APPEAL LODGED IN TERMS OF SECTION 79(2) OF THE STELLENBOSCH MUNICIPAL LAND USE PLANNING BY-LAW: APPLICATION FOR REZONING AND SUBDIVISION OF FARM NO 717/1, PAARL DIVISION WITH A DEPARTURE AND CONSENT USE

PROPOSED SUBDIVISION AND LAND USE
PORTION 1 OF FARM GROENFONTEIN No. 717
PAARL

MEMORANDUM

REMAINDER OF PORTION 1 OF FARM GROENFONTEIN 177 PAARL (KLAPMUTS): MAIN ROAD 27 AND MAIN ROAD 205: UPDATED TRAFFIC IMPACT ASSESSMENT FOR THE ORIGINAL APPLICATION FOR SUBDIVISION, REZONING AND CONSENT USE AND DEPARTURES

ACCESS TO FARMS 748/6 (POTBELLY / SUBTROPICO), 717 (CADCOR) AND 749 (HEEN EN WEER), KLAPMUTS
SUGGESTED INTERIM LAYOUT

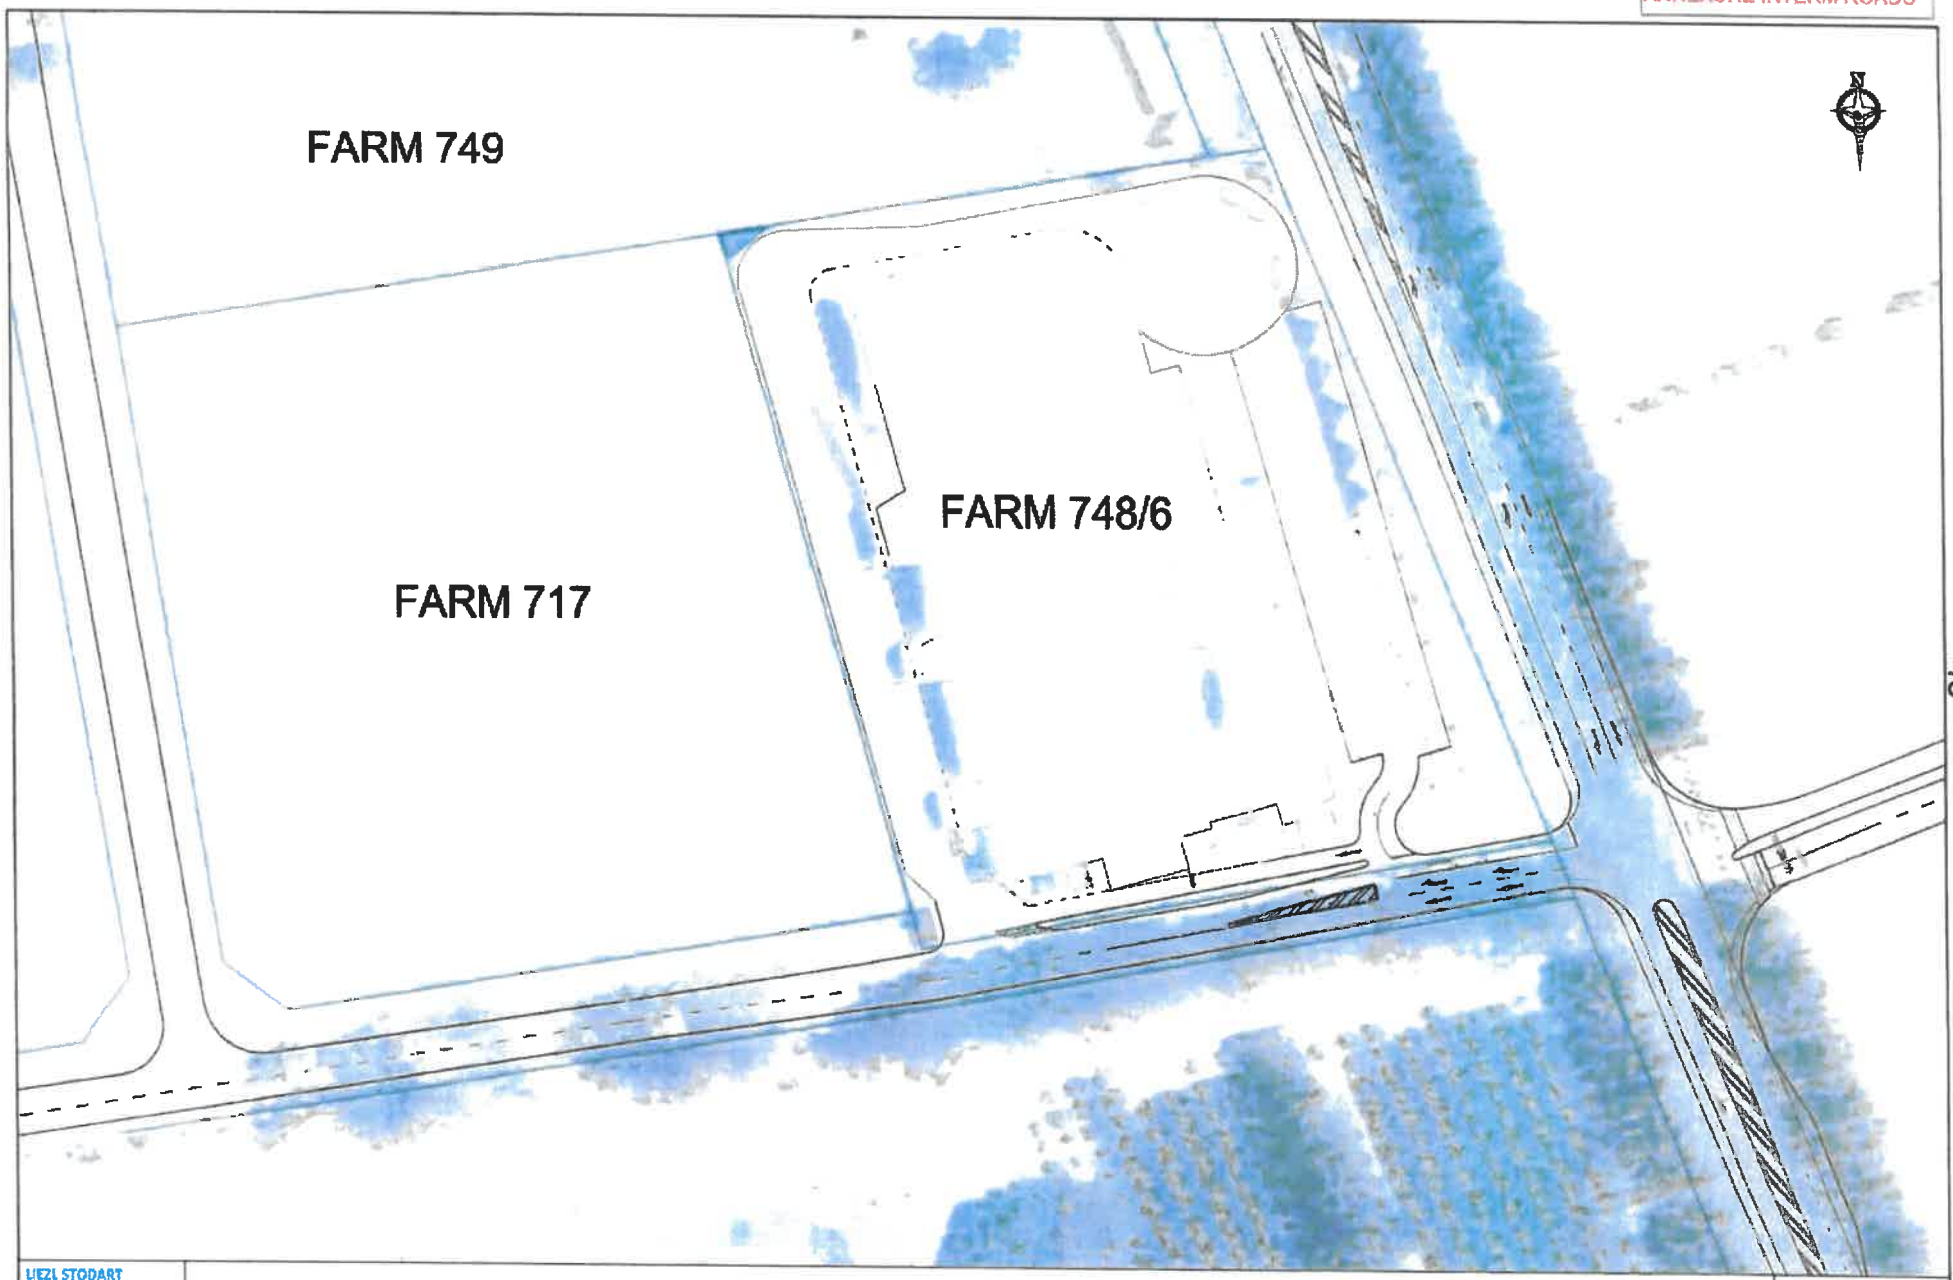
ultimate layout problematic at this stage. As an interim solution, access to Farm 717/1 must be constructed in accordance with DWG No LS143-G01 Rev 05 dated 2024-03-15 by Liezl Stodart (**Annexure: Interim Roads**). The section of road, between the R44 and the access to the Farm 717/1 development must be constructed before any subdivision clearance of Farm 717/1 is issued. Should the land become available for the construction of the ultimate layout, the Municipality will set such road construction conditions on any future land use applications.

ACCESS TO FARMS 748/6 (POTBELLY / SUBTROPICO), 717 (CADCOR) AND 749 (HEEN EN WEER), KLAPMUTS
LONG TERM FUTURE LAYOUT

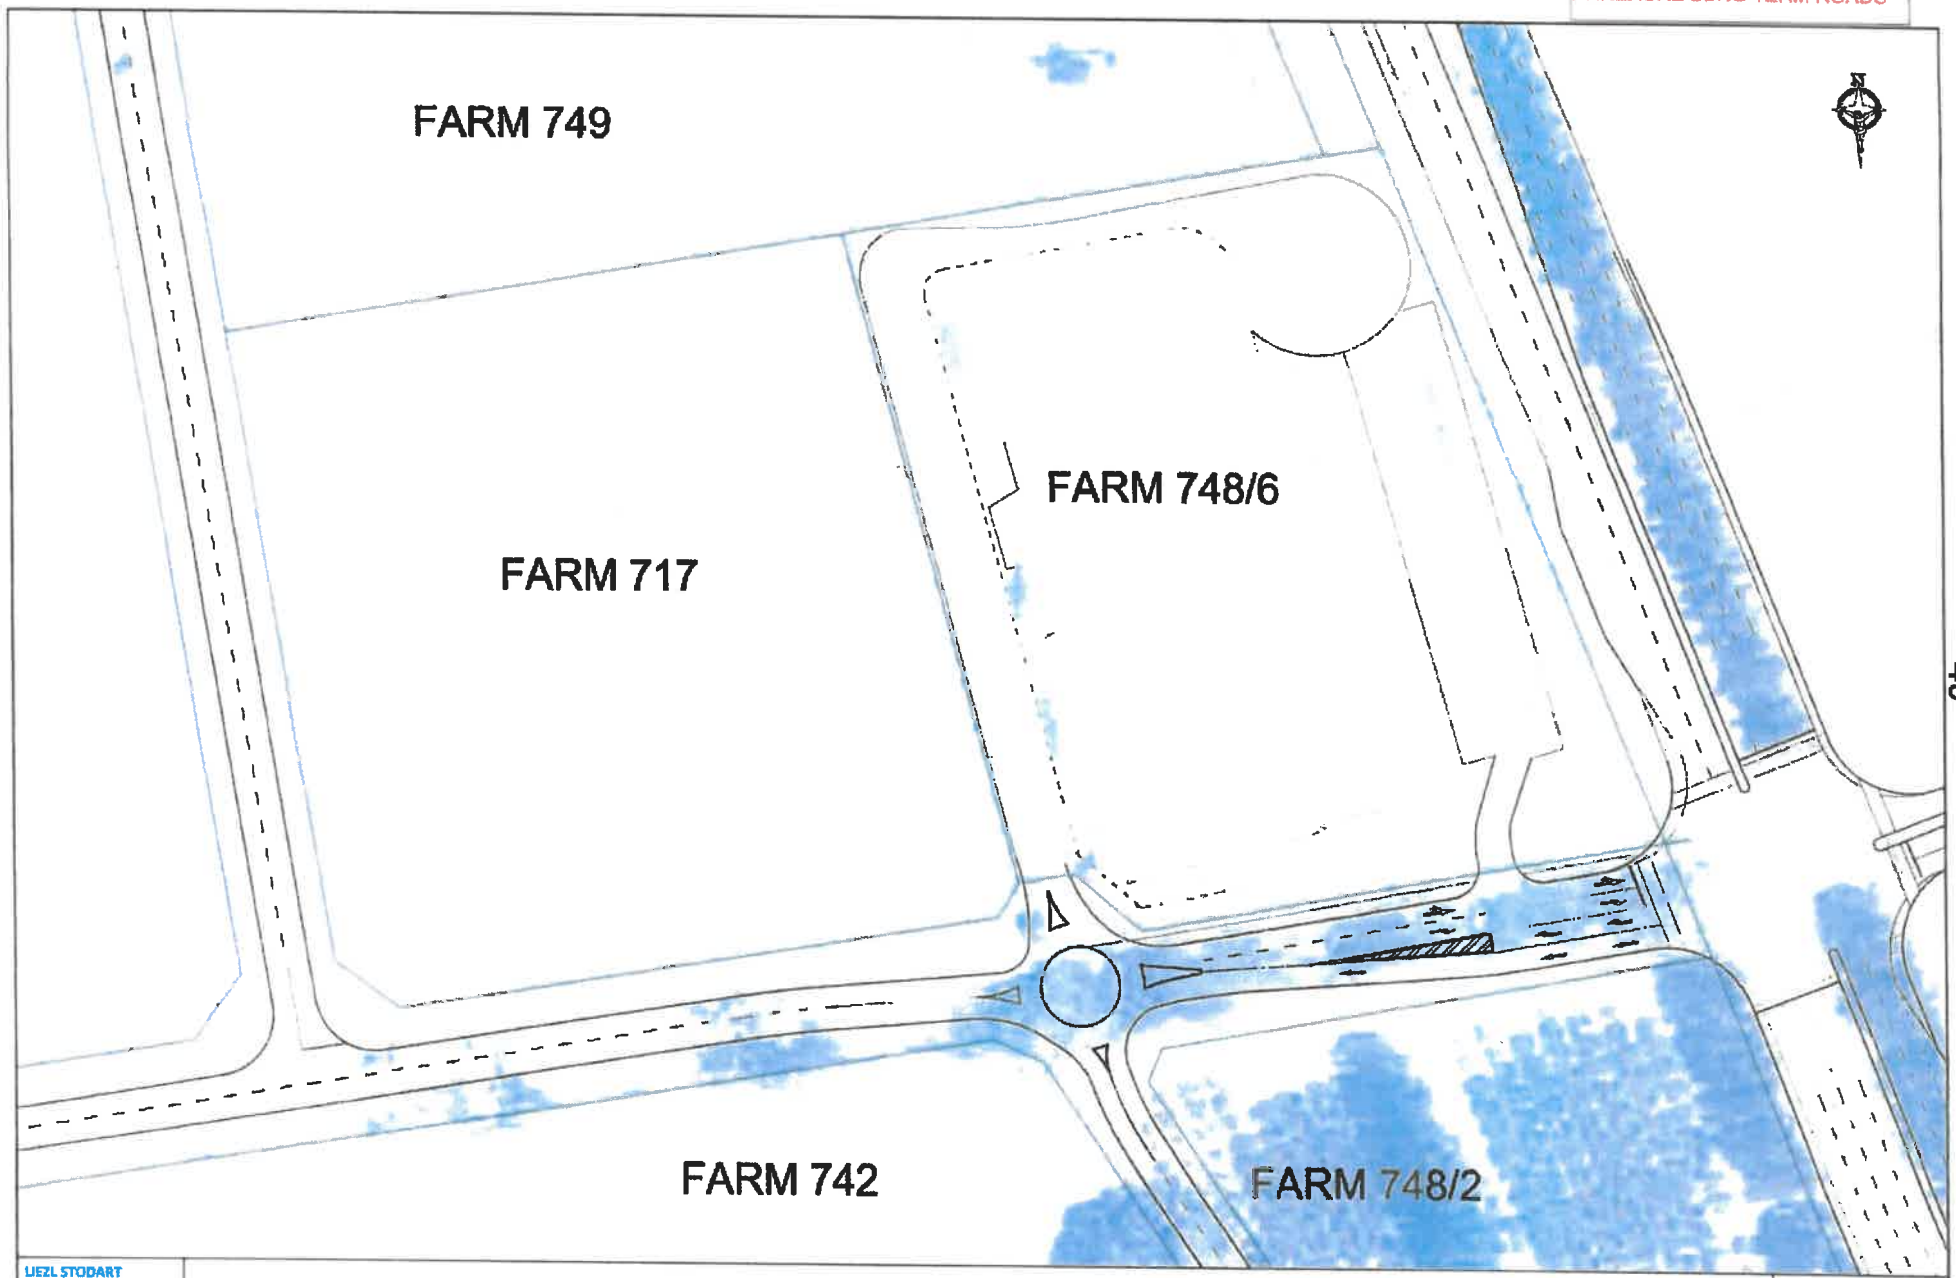
4.2.1 In order to construct the long-term road network (**Annexure Long term Roads**) that will give access to this development and other developments along this route, land is required from the properties to the south (Farm 742 and Farm 748/2). This is however not yet in place, which makes the construction of the
